DEPARTMENT OF CITY PLANNING
RECOMMENDATION REPORT

**SOUTH VALLEY AREA PLANNING
COMMISSION**

Case No.: DIR-2014-886-SPP-SPPA-2A
CEQA No.: ENV 2014-887-MND
Incidental Cases: None
Related Cases: DIR-2010-1000-SPP-SPPA
ENV-2010-1001-MND
Council No.: 2
Plan Area: Sherman Oaks – Studio City –
Cahuenga Pass – Toluca Lake
Specific Plan: Ventura/ Cahuenga Boulevard
Corridor
Certified NC: Studio City
GPLU: Neighborhood and General
Commercial
Zone: C1.5-1VL-RIO
Legal Portion of Lot 5, Tract 1368,
Description: Arb 2; Parcel Map 353, Lots A-
C, Arb 1
Applicant: Richard Weintraub,
Sportsmen's Lodge REW, LLC
Appellant(s): Patrice Berlin, Sandy Fox, Pam
Friedman, Marilyn Harris, Judy
Millar, Abbie Phillips, Michael
and Andrea Sher, Golan Yosef,
and Ventura Boulevard
Associates (c/o Midwood
Investment
Development/Steven
Schwartz/Kevin McDonnell

PROPOSED PROJECT: Demolition of the existing Sportsmen's Lodge event/banquet facility and the subsequent construction of a new, 97,807 square-foot, mixed-use shopping center, with 24,251 square feet of restaurant space, 37,518 square feet of retail space, 30,000 square feet of health club space, and 6,038 square feet of accessory space (i.e. hallways, ele

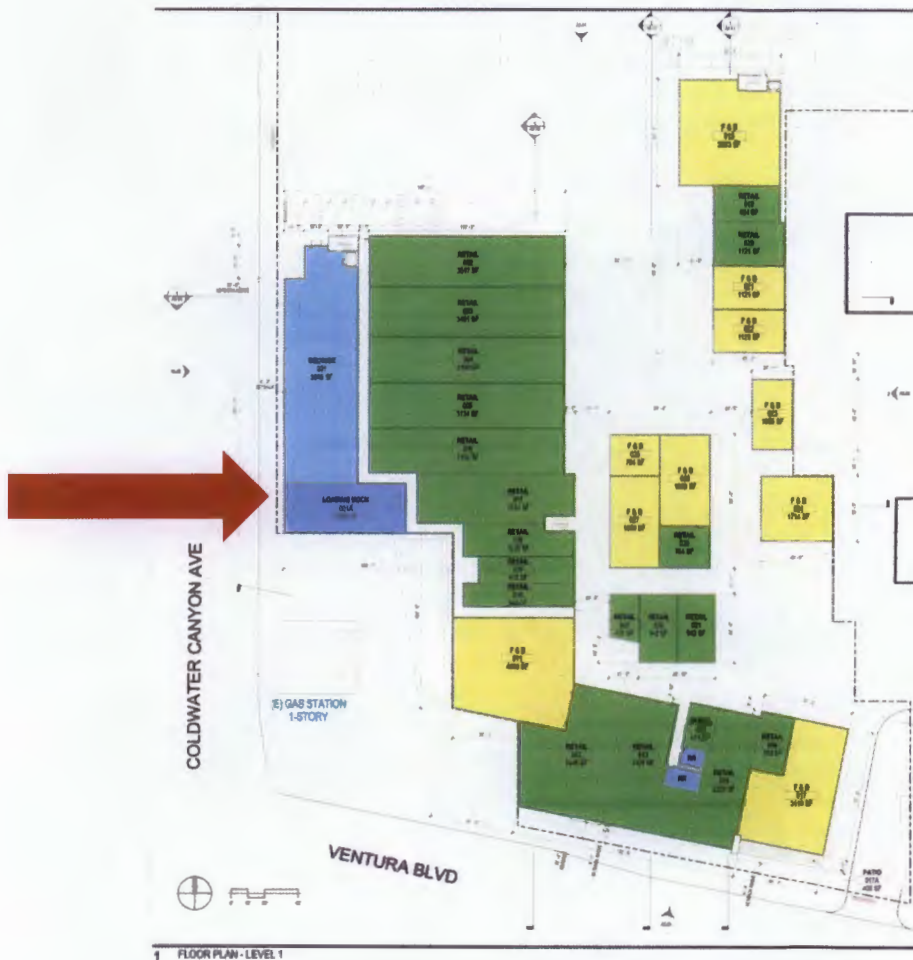
8) The Neighbors state that the proposed conditions of approval do not protect adjacent residential uses from light pollution emanating from the project site.

As conditioned by the Director's Determination letter (Exhibit E), Conditions C-7 - C.9 will restrict the amount of light that will be visible from the northern single-family neighbors and the patrons of the river by requiring that all Project lighting shall be directed onto the site and be adequately aimed and shielded so as to not spill over onto adjacent properties. In addition,

there will be ample foliage that will be located both along the river front and along the parking deck on the subject property to shield lighting from the businesses on the subject property. All lighting will be downward facing and, as required by the LA-RIO plan, cannot be directed towards the river. As a result, the adjacent residential uses will be protected from any light pollution.

Figure 1. Proposed Mechanical Equipment Locations 1-5 on Low Roofs of New Facility

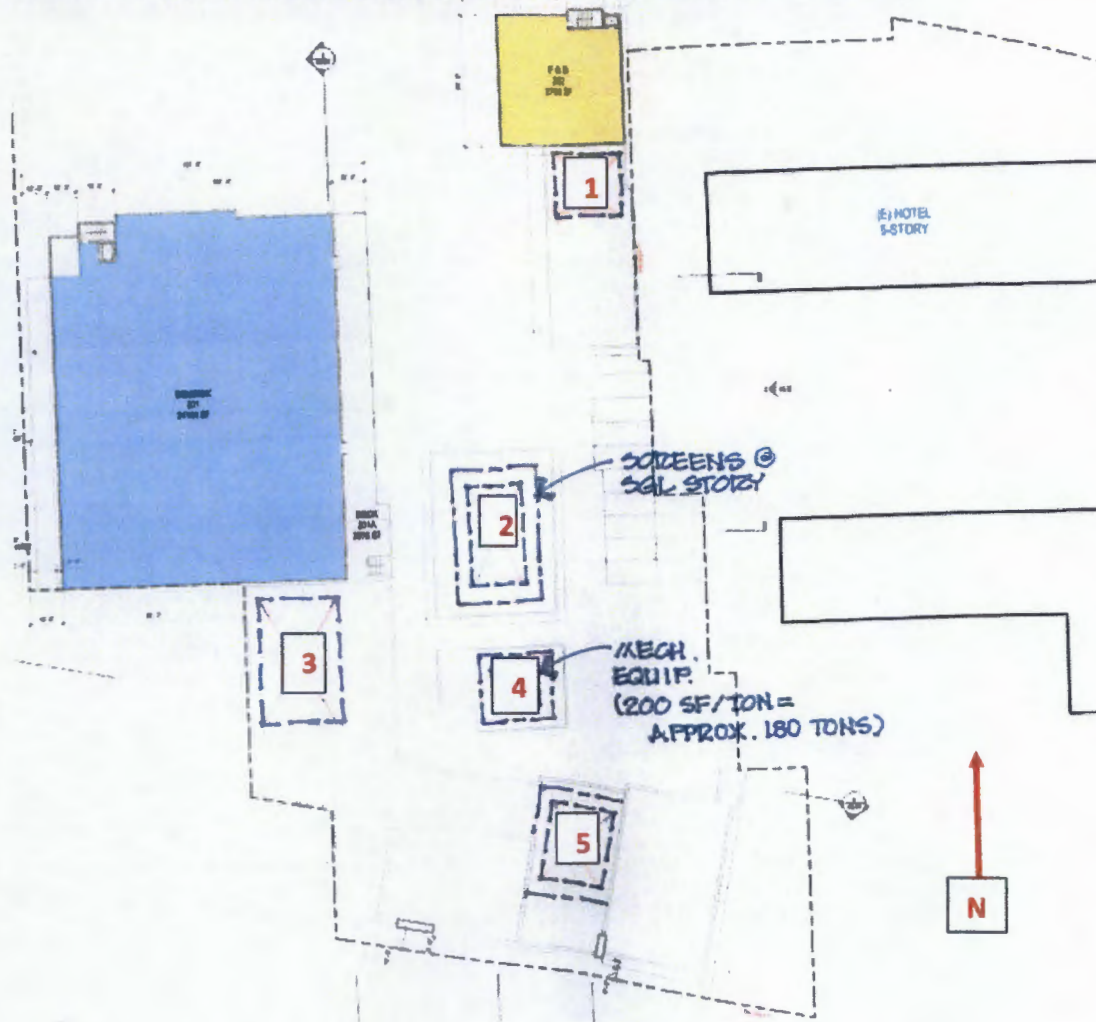
We understand that packaged AC units are proposed in five locations on the low roofs (i.e. one story tall) of the new facility. Please reference Figure 1, below. Screens are proposed around three of these locations (i.e. locations 2, 4, and 5 in Figure 1), and Sono-Con Class 1-E exterior acoustical panels by Phoenix-E are proposed as screens. Mechanical equipment location 1 will be the closest to the residences across the L.A. River to the north at approximately 284 feet. We understand that the proposed units will all be approximately 4 feet tall.

We understand that the high roofs of the F&B and Equinox Buildings (see Figure 1) will be 18 feet taller than the low roofs and therefore will offer some shielding from mechanical equipment locations 1 and 3, which is acoustically acceptable. In general, proposed low roof mechanical equipment should be located south of two-story portions of buildings.
